**Town of Davidson
Design Review Board Regular Meeting
Town Hall and Community Center
Community Room 120
251 South Street
Wednesday, February 18, 2026 at 5:30 PM**

a. Summit Farms Bakery & Market Buildings – Informal Review

DESIGN REVIEW BOARD: PRELIMINARY STAFF REPORT

Date: February 18, 2026
To: Design Review Board
From: Lindsay Laird, Senior Planner
Re: Summit Farms Bakey & Market Buildings – Preliminary Review

SHEET # **A6.0**

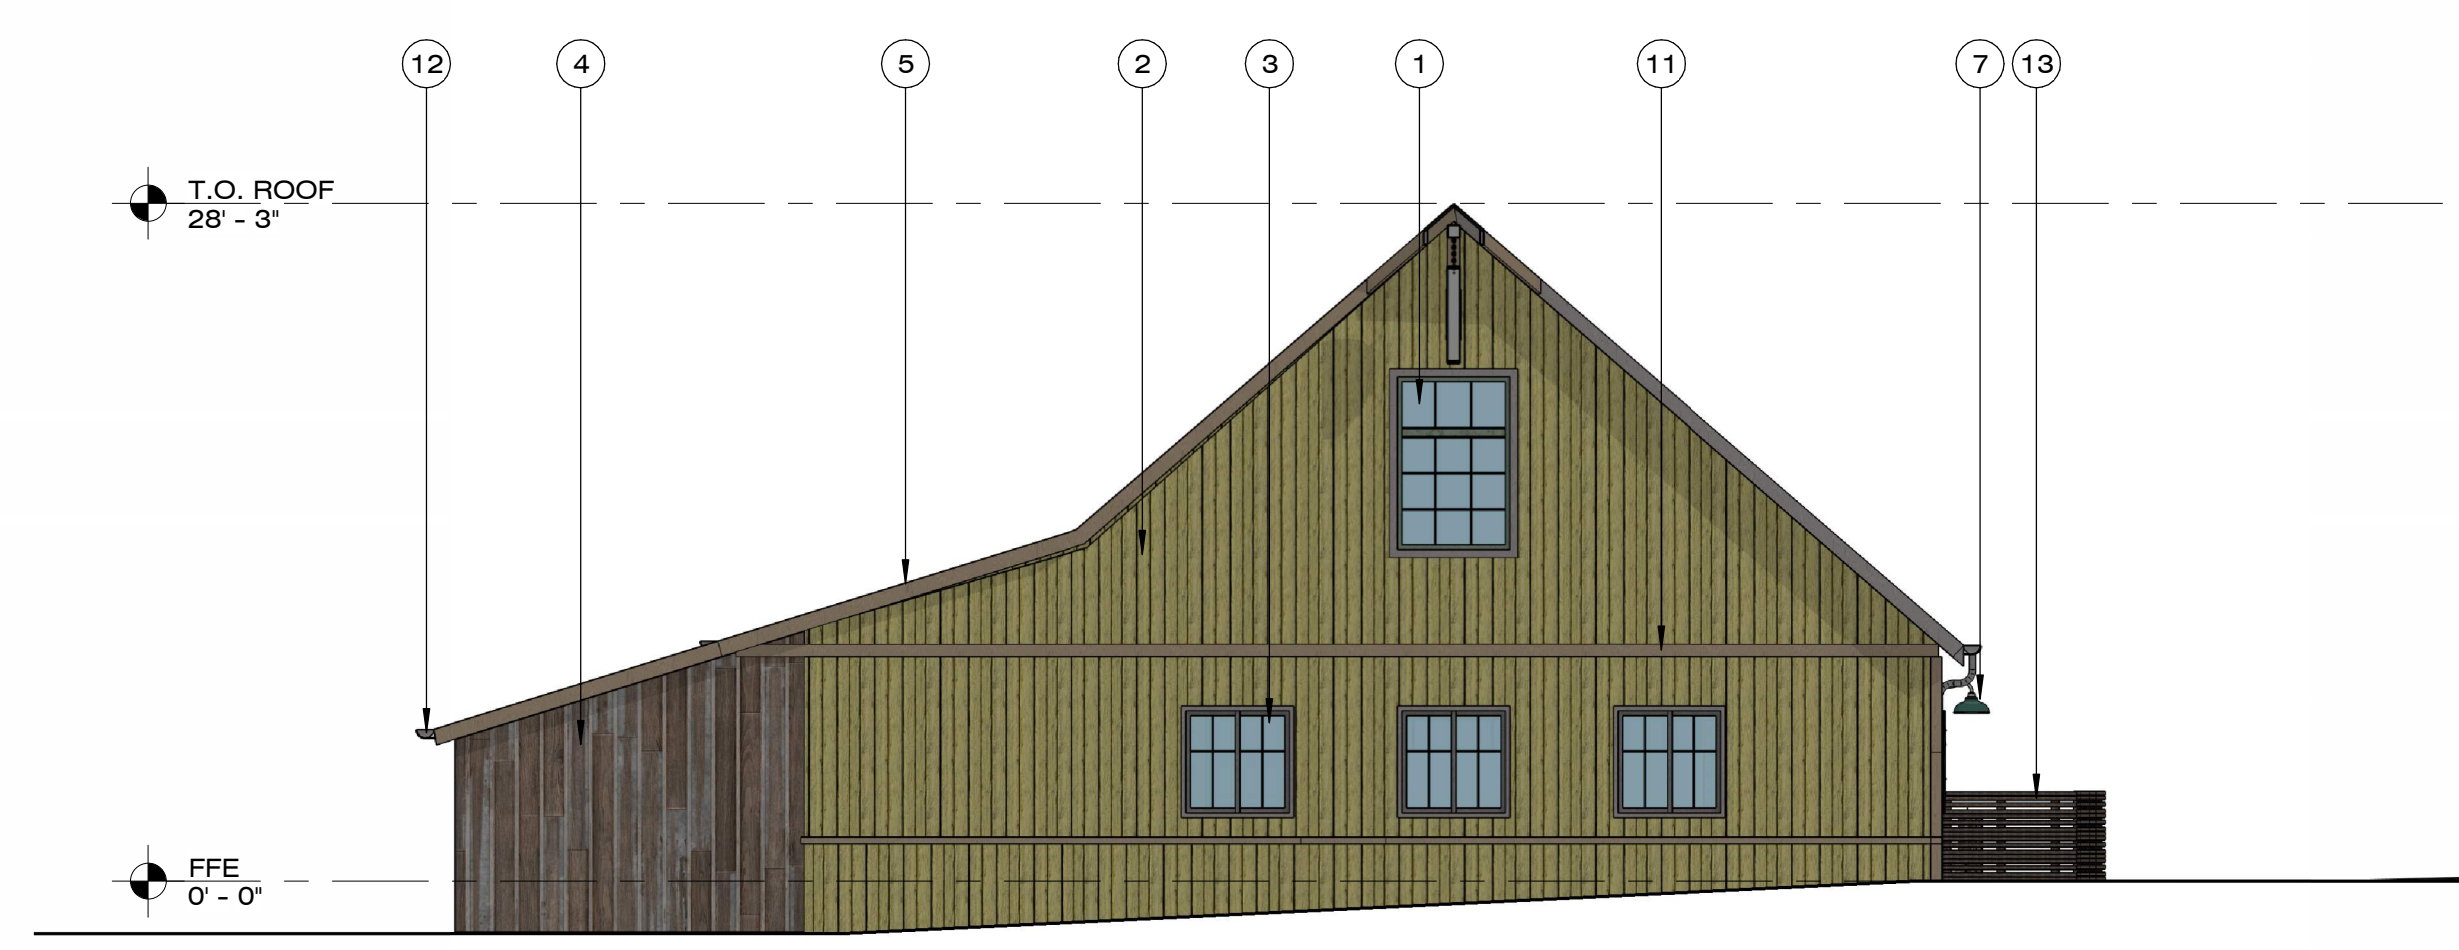
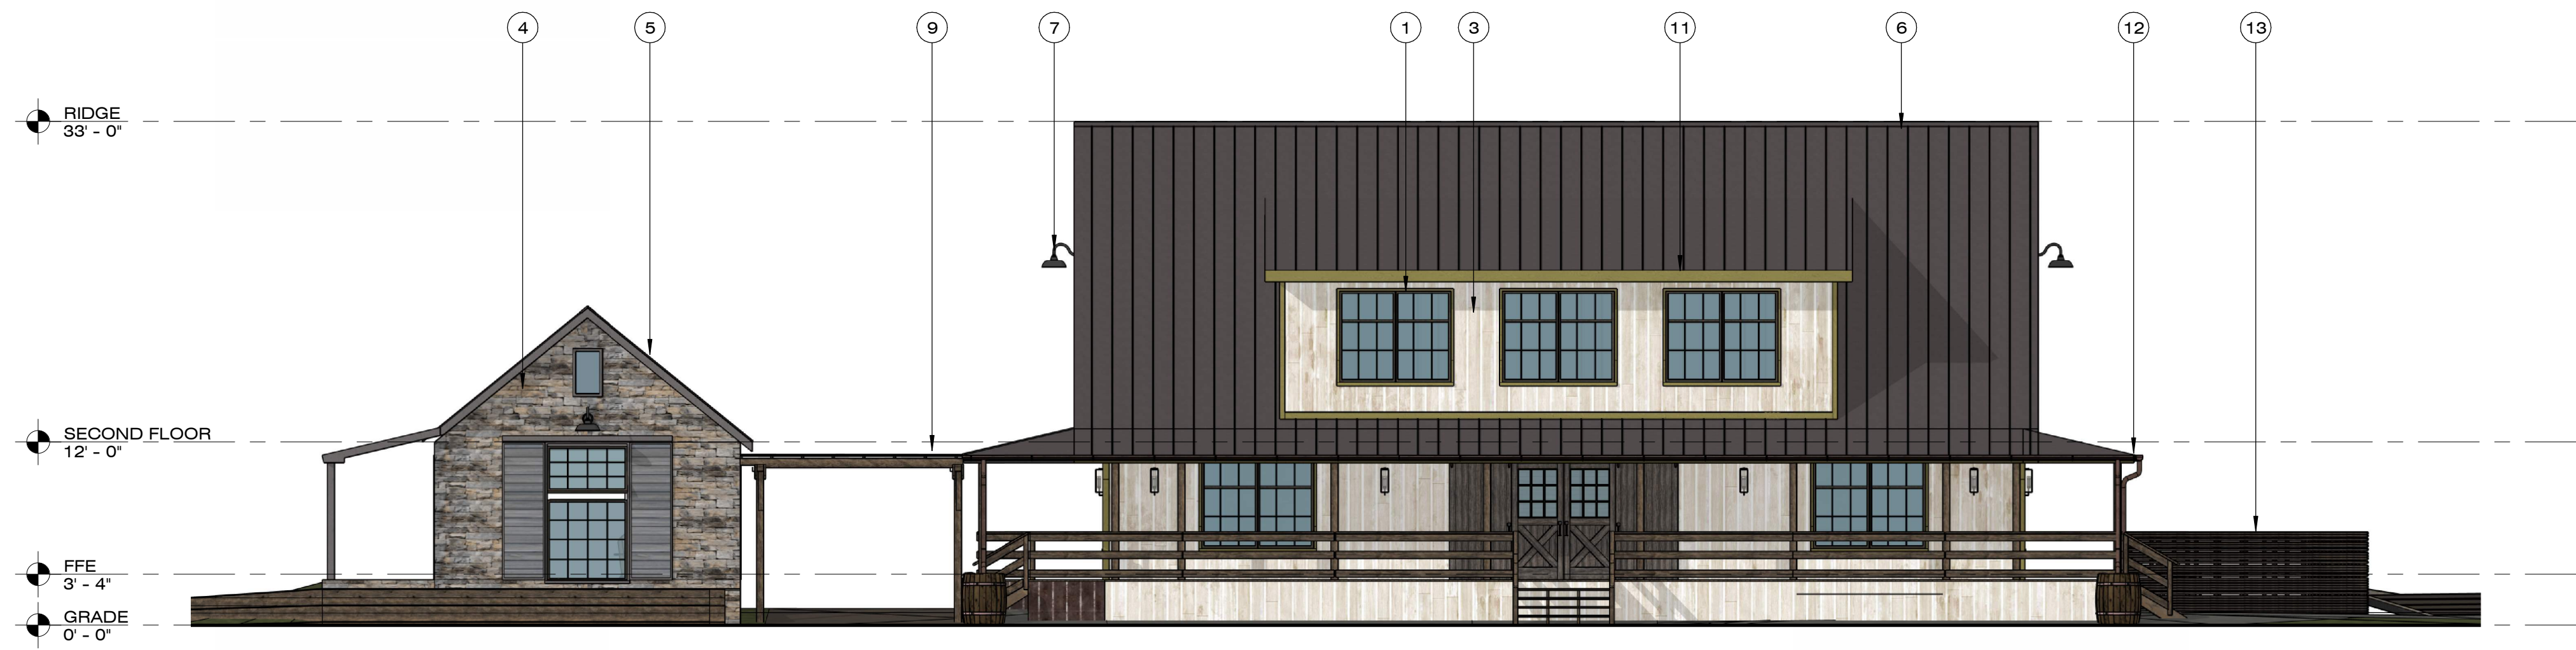
Determine if the proposed design is consistent with rural vernacular architecture.

Confirm that Summit Farms storefront buildings are articulated as two full stories from the exterior.

Confirm building facades are divided into an asymmetrical, yet balanced, composition.

Confirm that building facades are adequately articulated.

Confirm that architectural details are arranged and proportioned so that vertical dimensions dominate horizontal dimensions. Confirm that architectural elements establish human scale at the street/plaza level and that entrances are adequately emphasized.

Confirm design/materials are consistent with rural vernacular architecture.
